SERVICE PROCEDURE

18504

SUBJECT: SAFETY RECALL

Brake Air Line Routing on certain International® HX® Series trucks built 08 December 2015 thru 10 February 2018 with feature code 04091 (dual air brake system) and 04AZY (Antilock Brake System [ABS] with 6 channel Electronic Stability Protection [ESP])

Figure 1. ATR-6 Valve

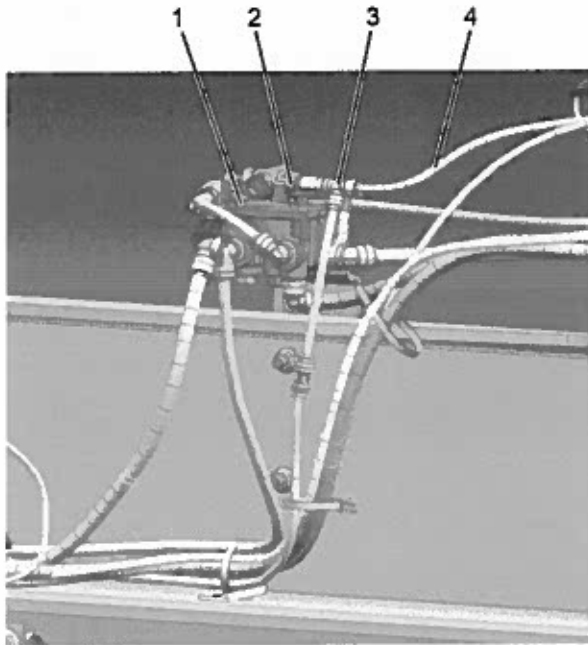
1. ATR-6 valve
 2. Control port
 3. 45-degree fitting
 4. 3/8-inch ORANGE airline
6. Disconnect ORANGE 3/8-inch airline (Figure 1, Item 4) from 45-degree fitting (Figure 1, Item 3) of ATR-6 control port (Figure 1, Item 2).
7. Remove and discard 45-degree fitting (Figure 1, Item 3) from ATR-6 control port (Figure 1, Item 2).

Figure 2. Tee-Fitting

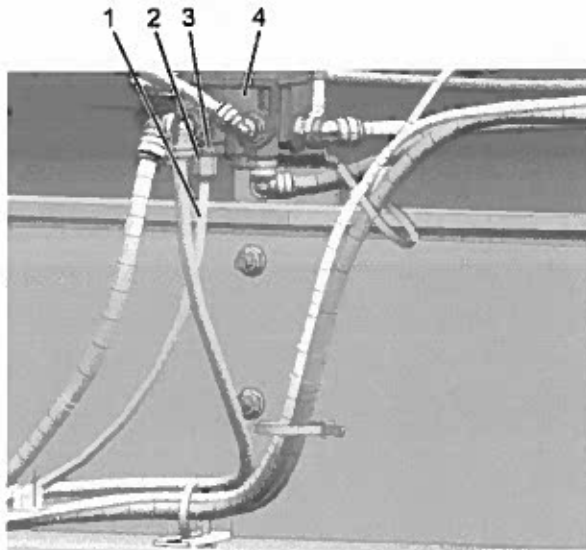
8. Install new 3/8-inch T-fitting (Figure 2, Item 3) into ATR-6 control port (Figure 2, Item 2) and hand tighten nut.
9. Tighten fitting 1-1/2 to 2 full revolutions.
10. Install ORANGE 3/8-inch airline (Figure 2, Item 4) into 3/8-inch T-fitting (Figure 2, Item 3).

Figure 4. ATR-6 Connections

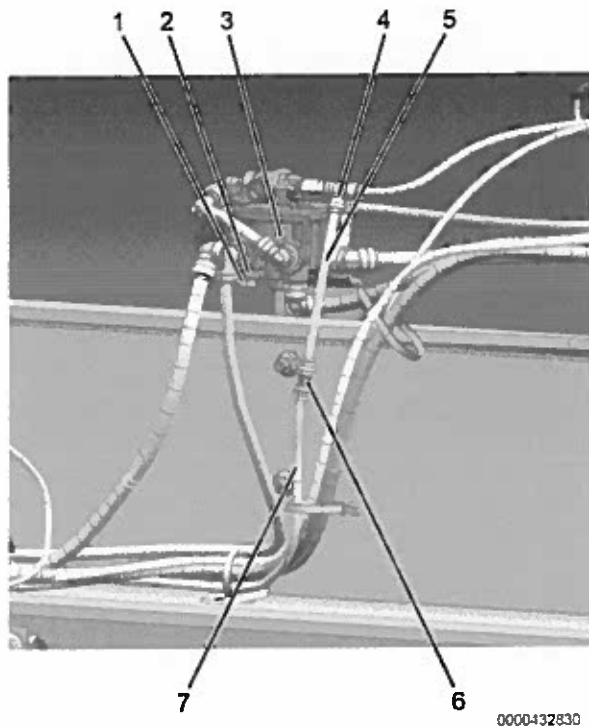
13. Install 3/8-inch plug (Figure 4, Item 1) into ATR-6 steer axle delivery port (Figure 4, Item 2) and tighten until plug is hand tight.
14. Tighten plug 1 1/2 to 2 full revolutions.
15. Install one end of 7-inch (180 mm) length 3/8-inch ORANGE airline (Figure 4, Item 5) into 3/8-inch coupler (Figure 4, Item 6).
16. Install 3/8-inch coupler (Figure 4, Item 6) onto lower 3/8-inch ORANGE airline (Figure 4, Item 7).

17. Install remaining end of 7-inch (180 mm) length 3/8-inch ORANGE airline (Figure 4, Item 5) into 3/8-inch T-fitting (Figure 4, Item 4).
18. Verify no air leaks are present when pedal is depressed.
19. Remove wheel chocks.
